FAQ Title NFPA 805 Monitoring

| Plant: | Harris Nuclear Plant | Date: | January 13, 2012 |

The purpose of this FAQ is to clarify the following for the NFPA 805 monitoring program:

Figure E-1 – NFPA 805 Monitoring Process

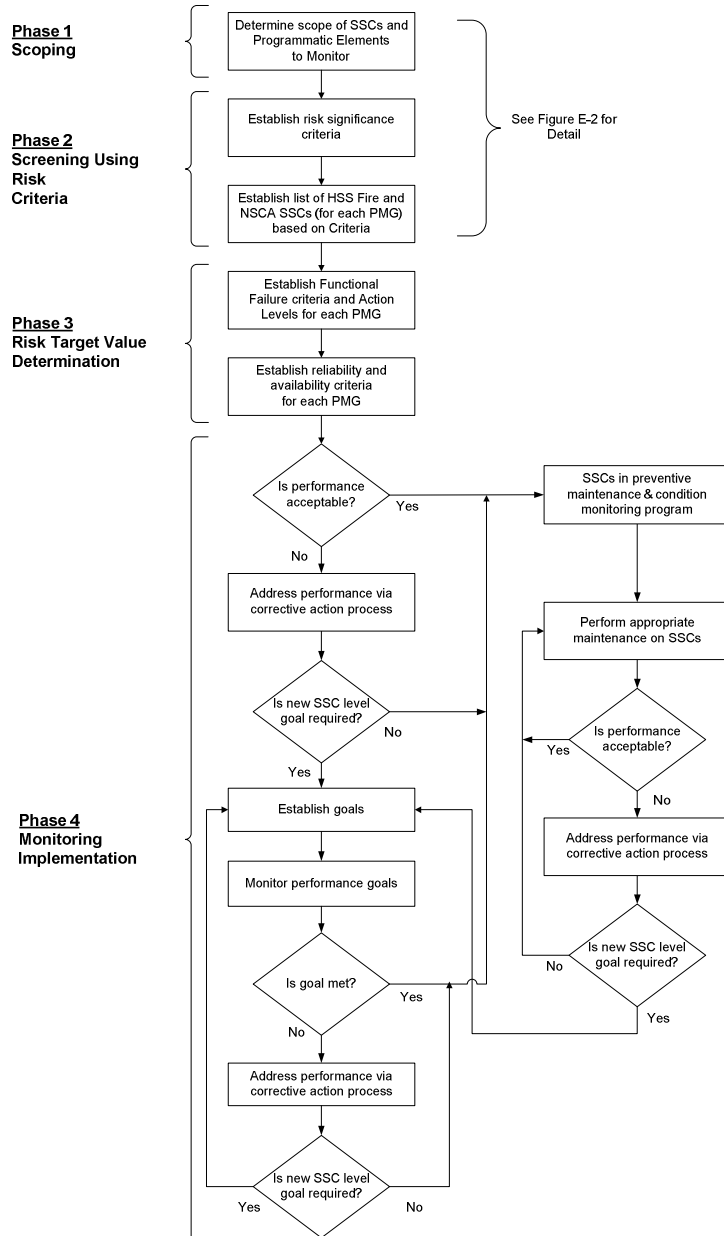
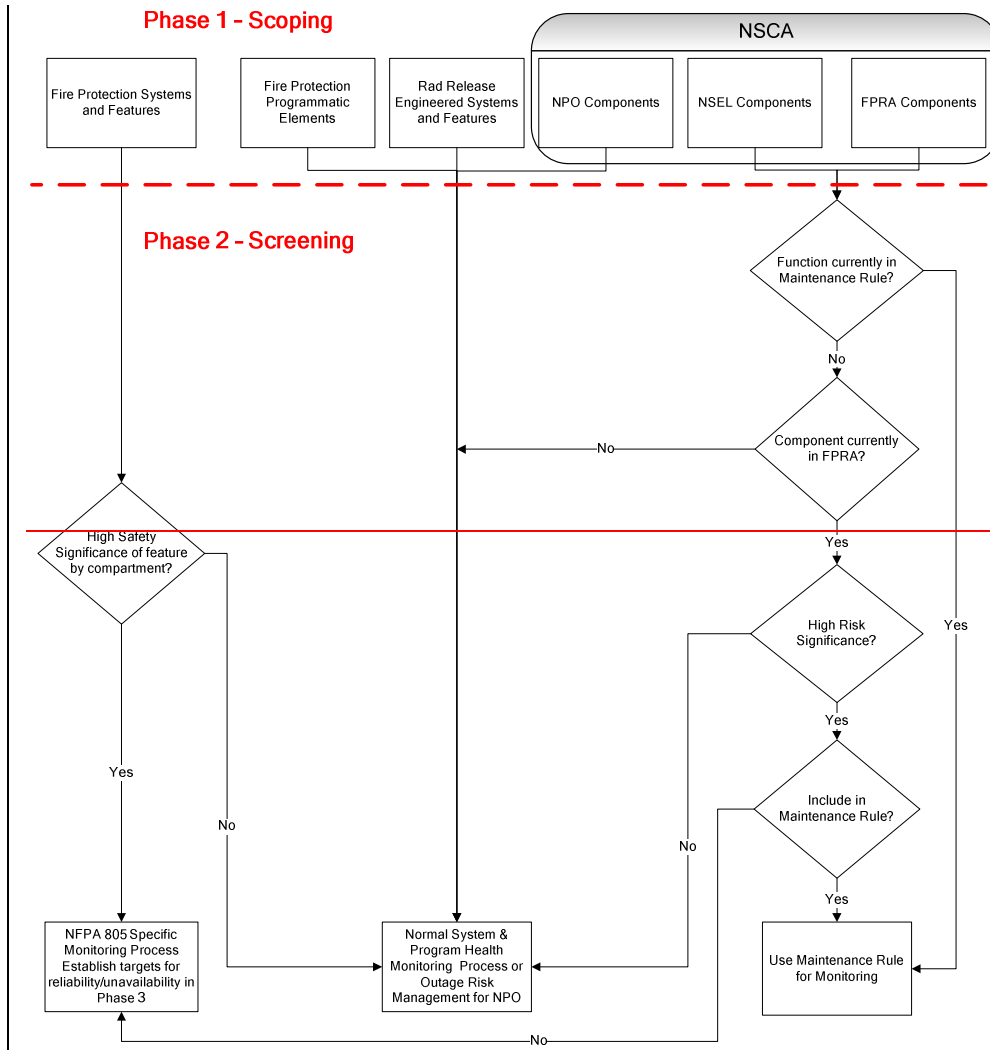
REPLACE ALL OF APPENDIX E WITH THE FOLLOWING:

A suggested methodology is outlined below. Figure E-1 provides an overview of the Monitoring Process, while Figure E-2 provides detail on a process for Phases 1 and 2.
